# 1501253 BC Ltd.'s responses to KIA's Review dated March 18, 2025.

**Date:** March 25, 2025

**Subject:** Response to Environmental Protection Operations Directorate's review of 1501253 BC Ltd.'s Type B Water Licence Application 2BE-CPM---- for the Coppermine Project

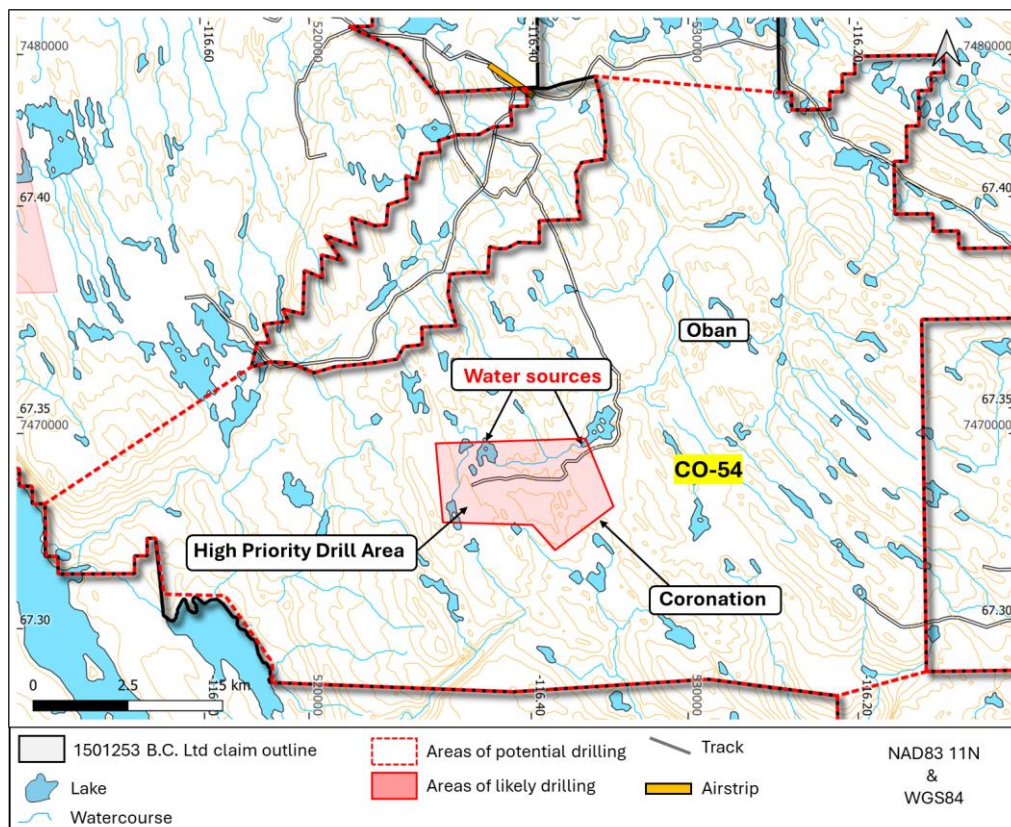
**Recommendation 2:** The proponent provide the location of drilling activities in relation to local water sources.

**Response 2:** Should water be taken for drilling purposes (which is unlikely as we plan on using an RC drill rig, which is a dry drilling method, and no camp is being proposed), water would be taken from nearby small lakes or streams close to the drill location. If water is taken for drilling purposes, it will be done by a small pump sitting in a secondary containment bund, with a mesh fitted over the intake hose.

Please see below image for highest priority drill location on CO-54, where the majority of the 15 planned holes are likely to occur, and lakes and water courses in the area which may be used as water sources. Due to the early-stage nature of mineral exploration, ongoing interpretation, and need to collect further data in the field, it is not possible to dictate the exact collar locations of the drillholes yet. The location where drilling will likely occur is shown on the map. During the entire program, drilling will only occur more than 31 metres away from the ordinary high-water mark of any water body, and no wastewater will be deposited into any water bodies, or closer than 31 metres from the ordinary high-water mark of any water body. Small hand-dug sumps will be used to dispose of any wastewater, none of which will contain any pollutants or hazardous materials.

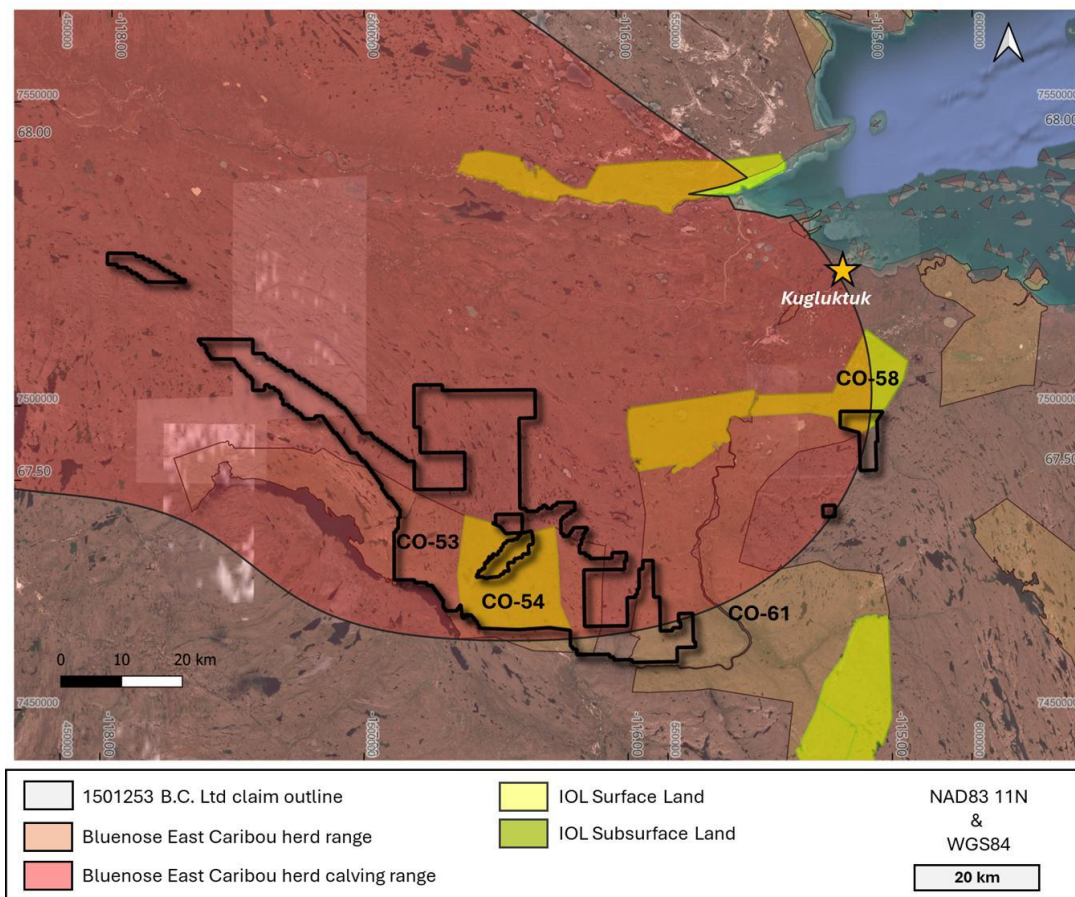
*It is unknown to KIA whether the general locations and dates of when caribou calving and post- calving typically occur in this area (and the parcels themselves) and if so, these should be specified in the MP so as to ensure they aren't missed.*

**Response:** The outline for the Bluenose East caribou herd geographical calving range is shown on a map below, in the attached 'Maps IOL Application V2', and was submitted to the KIA in the separate IOL use application. The dates of 28<sup>th</sup> May – 3<sup>rd</sup> July are mentioned in the Project Summary and NPC determination attached to the water permit application. This geographic outline of caribou calving comes from the 2011 paper by Nagy et al., titled 'subpopulation structure of caribou (*Rangifer tarandus* L.) in arctic and subarctic Canada', which shows the annual and calving range of the Bluenose east caribou herd.

Another paper by J.A. Nagy et al, titled 'Seasonal Ranges of the Cape Bathurst, Bluenose-West, and Bluenose East Barren-Ground Caribou Herds', 2005, (attached) defines the bluenose east caribou herd calving and post-calving dates as being from 28<sup>th</sup> May – 20<sup>th</sup> June. Delaying work until the 3<sup>rd</sup> of July as proposed allows a 2-week buffer after post-calving.

This proposed shutdown period calving date range (28<sup>th</sup> May – 3<sup>rd</sup> July ) used for this application was taken from White Cliff Minerals approved permits (NPC determination 150522, NIRB 24EN047) for exploration work done in 2024. This map and references has been added to the Wildlife Management Plan, which is attached.
